# Blessington Greenway

Stage 1 Road Safety Audit

Wicklow County Council

Project number: 60617025  
Doc Ref: 60617025-RSA1

Figure 5-2 - Narrow Footpaths on Blessington Bridge

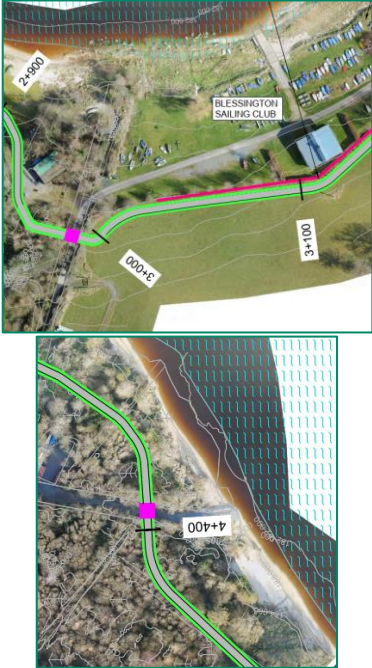
<b>5.1.2. Problem</b>		
<i>Location:</i>	Blessington Bridge; Baltyboys Bridge & Valleymount Bridge	
<i>Drawing:</i>	60617025_SHT_DD_BLGWY_142	
<i>Summary:</i>	Narrow Footpaths	
<b>Description:</b>

The Blessington, Baltyboys, and Valleymount Bridges will be a connection between proposed sections of the Greenway. As a single carriage way with a narrow footpath on the southern side of the road, it is unclear if there will be enough width for the cyclist and pedestrian to safely use these facilities to pass one another. The narrow footpath may lead to cyclists or pedestrians entering onto the carriageway to pass opposing pedestrians/cyclists, which can lead to pedestrian or cyclist collision. The lack of width on the footpath to accommodate pedestrian and cyclist passing may lead to cyclist/pedestrian collisions.

<b>Recommendation:</b>
Provide appropriate facilities to ensure pedestrians and cyclists can pass safely.

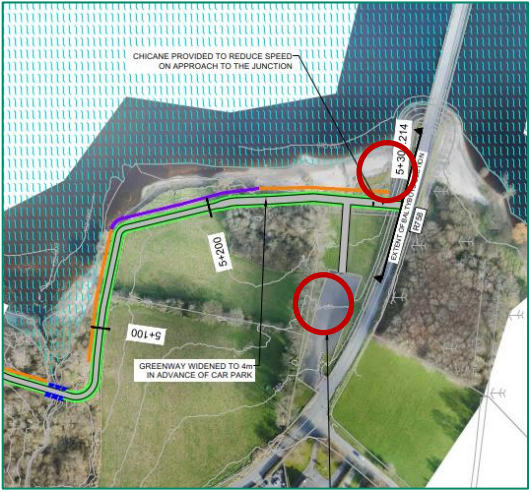
<b>5.3.1. Problem</b>		
<i>Location:</i>	Baltyboys Section connection to the Tulfarris Loop	
<i>Drawing:</i>	60617025_SHT_DD_BLGWY_142	
<i>Summary:</i>	Restricted visibility to crossing connection	
<b>Description:</b>		
<p>The connection between the Baltyboys and the Tulfarris schemes is proposed at the junction of the R758 and the local L8360 road. The R758 is posted as an 80km/h speed limit but vehicle speeds at this location. High through speeds on the R758 at this location might lead to vehicle users not observing cyclists crossing at this location which may result in the vehicle unable to stop in time and can lead to NMU/vehicular collisions.</p>		<p>Figure 5-16 – Visibility to Greenway Crossing Point</p>
<b>Recommendation:</b>		
<p>Ensure sufficient forward visibility and signage is provided on the R758 and L8360 road to indicate the presence of the cycle access and potential for NMUs crossing the R758.</p>

Problem 5.2.1.

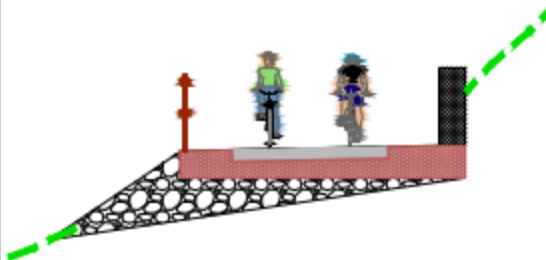
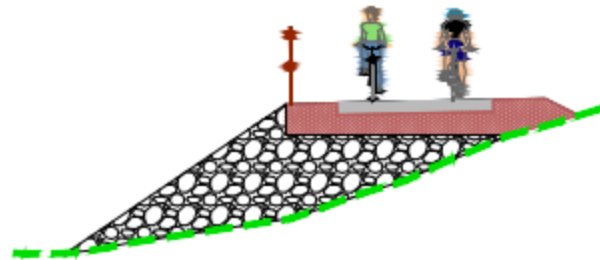
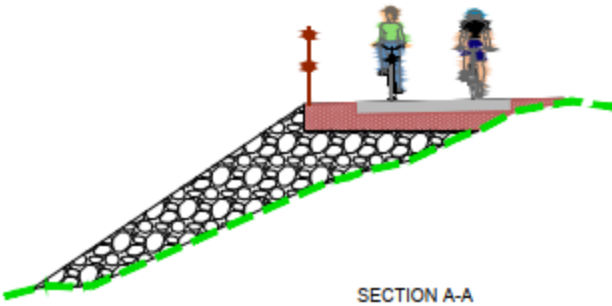
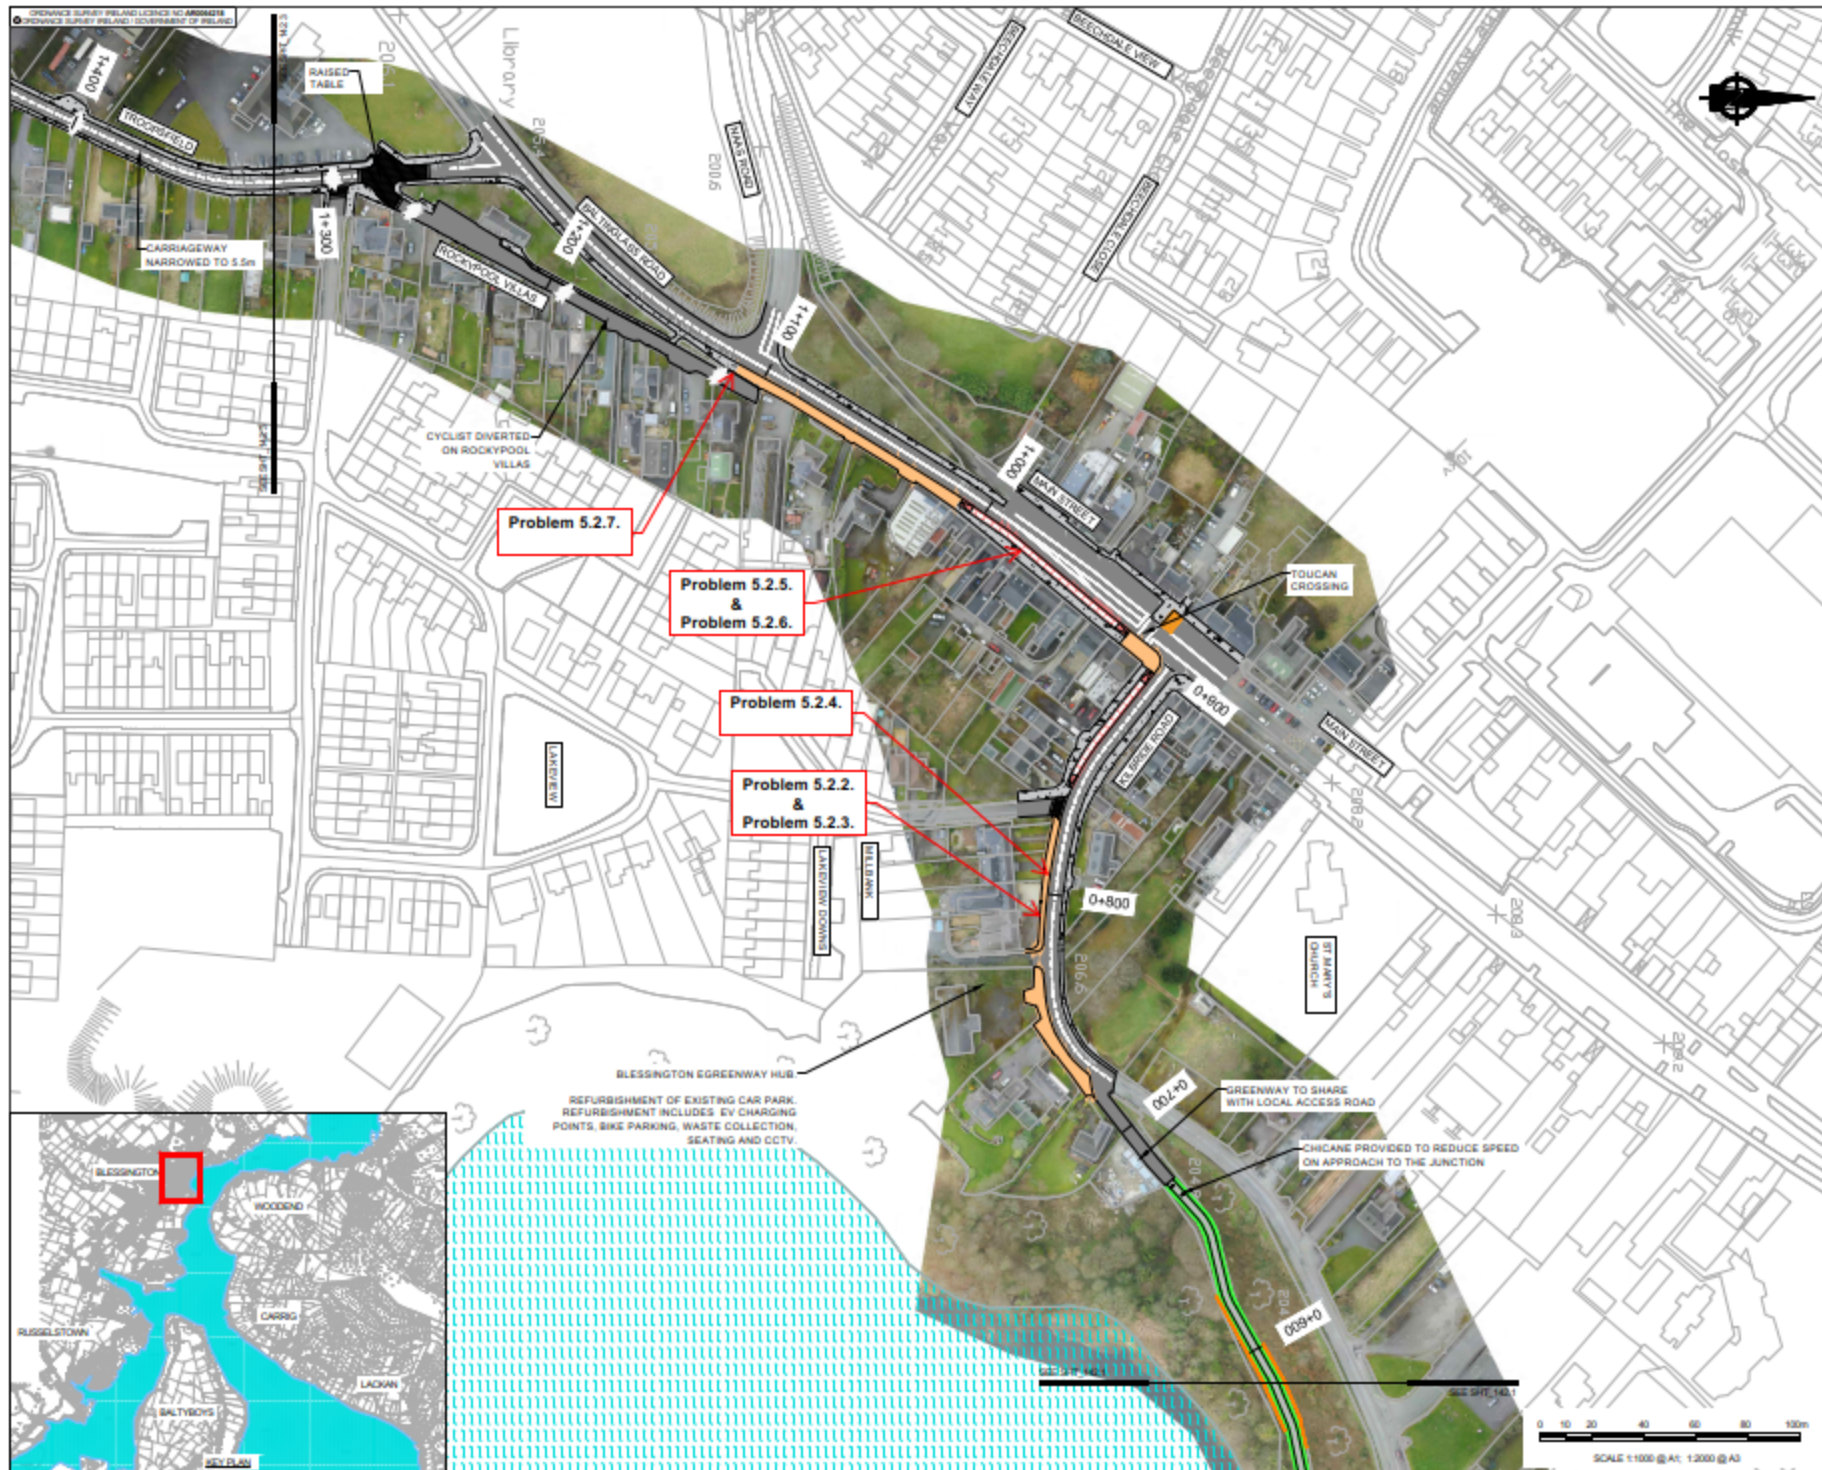
<b>5.2.1. Problem</b>		
<b>Location:</b>	Blessington Bridge	
<b>Drawing:</b>	60617025_SHT_DD_BLGWY_142-Blessington	
<b>Summary:</b>	Visibility for Greenway users on the approach to the Blessington Bridge	
<b>Description:</b>		
<p>The approach to the Blessington Bridge will connect to the footpath on the eastern side of the Blessington Bridge, During the site inspection it was observed that the slope on the approach to the abutment of the bridge would be quite steep. The Blessington Bridge Road is elevated above adjacent ground level at this location. There is no footpath or verge provision on the western side of the Blessington Bridge Road to facilitate NMUs. As the Greenway will rise to connect to the bridge, it is unclear to the auditors if there is sufficient visibility to Greenway users from vehicles travelling on the carriageway.</p>		
<b>Recommendation:</b>		
<p>Appropriate gradient levels on the approach to the Blessington Bridge Road should be provided, as well as appropriate signage and visibility requirements at the connection location.</p>

**Problem 5.1.3.**

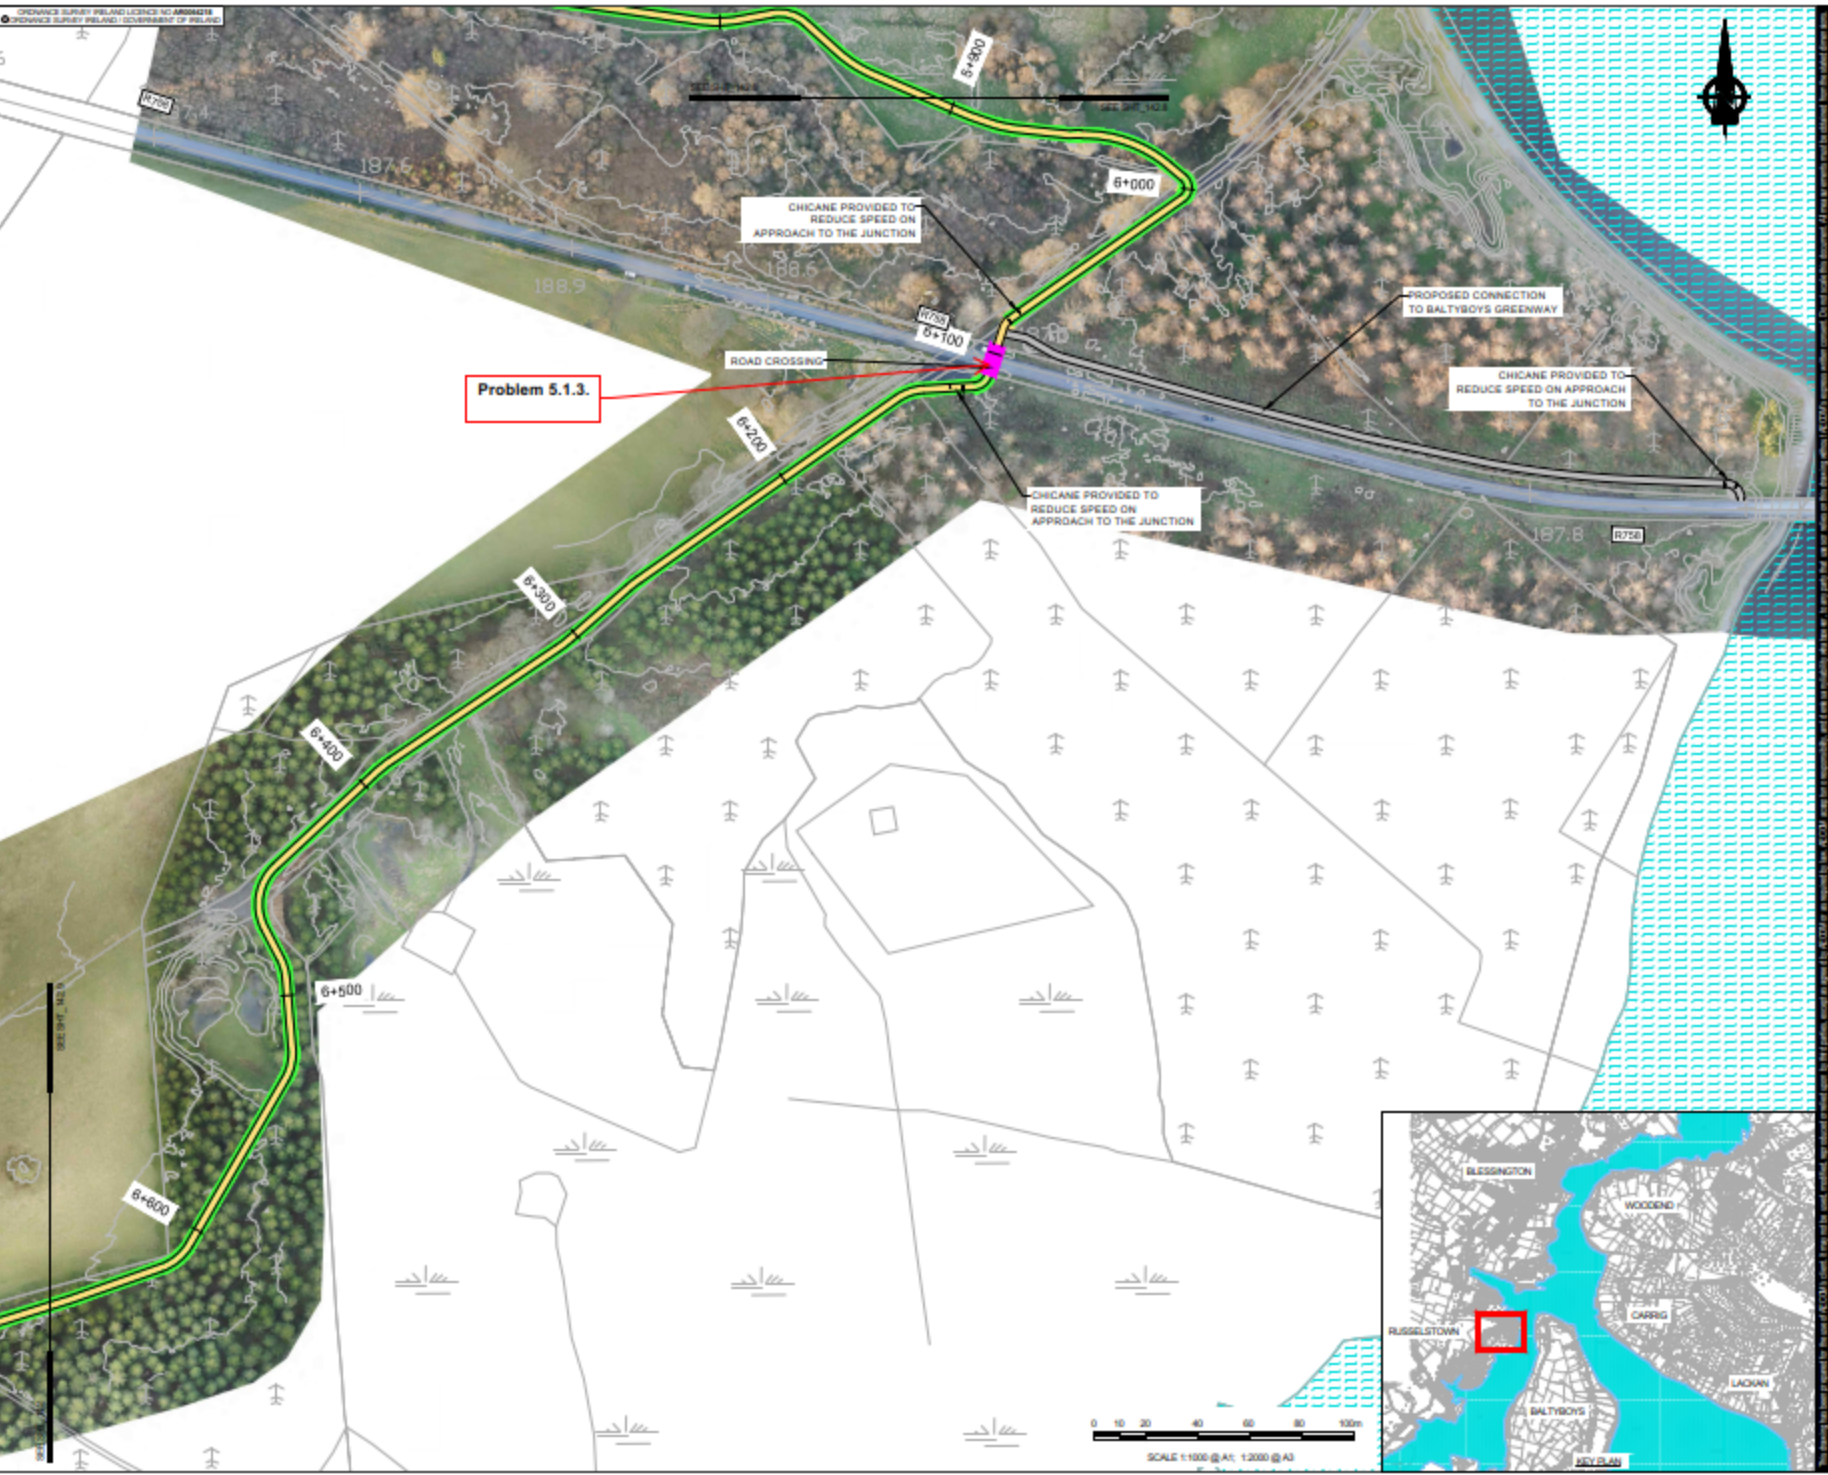
<b>5.1.3. Problem</b>	
<b>Location:</b>	Road Crossing (Scheme Wide)
<b>Drawing:</b>	60617025_SHT_DD_BLGWY_142
<b>Summary:</b>	Provision of road crossings for cyclists and pedestrians
<b>Description:</b>	 <p>Figure 5-3 –Public Road Crossings</p>

On the scheme there is a few proposed roads crossing points, where the proposed route will cross an existing road such as the R758, Access Road to Blessington Sailing Club, Vallemount Road. It is unclear to the audit team what arrangements will be provided for the road crossing at these locations. The lack of the safe crossing arrangements can lead to users to enter into traffic, this can cause a cyclist/pedestrian collision.

<b>Recommendation:</b>
Provide appropriate crossing points on all road crossing points.

**Problem 5.2.11.**

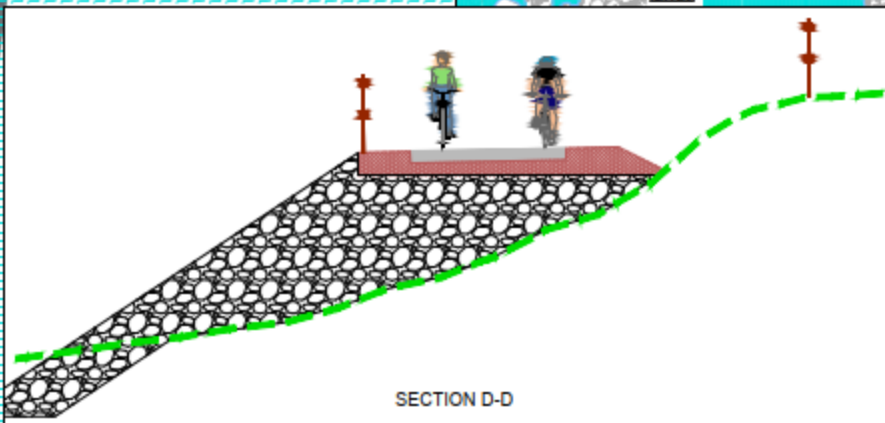
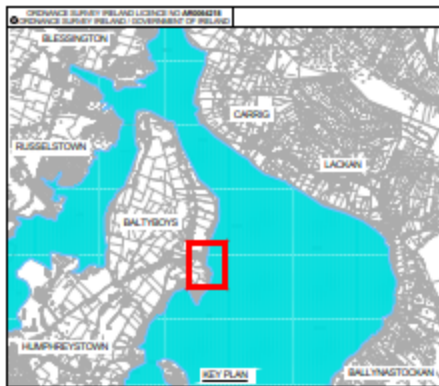
<b>5.2.11. Problem</b>		
<i>Location:</i>	N81 – Connection with Russborough House & Park	
<i>Drawing:</i>	60617025_SHT_DD_BLGWY_142-Blessington	
<i>Summary:</i>	Restricted Headroom at tunnel	
<b>Description:</b>		
<p>The proposed greenway is to link into the Russborough House estate via a tunnel below the N81. This tunnel has a restricted headroom, which will restrict the cyclist using this crossing. This may lead to cyclists attempting to cross the N81 at unsafe locations where vehicles do not expect NMUs crossing the road, which could lead to cycle/vehicle collisions.</p>		<p>Figure 5-15 – Restricted Headroom at tunnel in Russborough House &amp; Park</p>
<b>Recommendation:</b>		
<p>Appropriate provision of the clear headroom space should be provided, or appropriate signage provided to direct Greenway users to alternate crossing locations or restrictions.</p>

5.2.8	Yes	Yes			
5.2.9	Yes	Yes			
5.2.10	Yes	Yes			
5.2.11	Yes	No	Existing tunnel and connection not to be upgraded. This will not be part of the greenway and there will be no signage advertising this route.		Yes
5.3.1	Yes	Yes			
5.3.2	Yes	Yes			
5.3.3	Yes	Yes			
5.4.1	Yes	Yes			
5.7.1	Yes	Yes
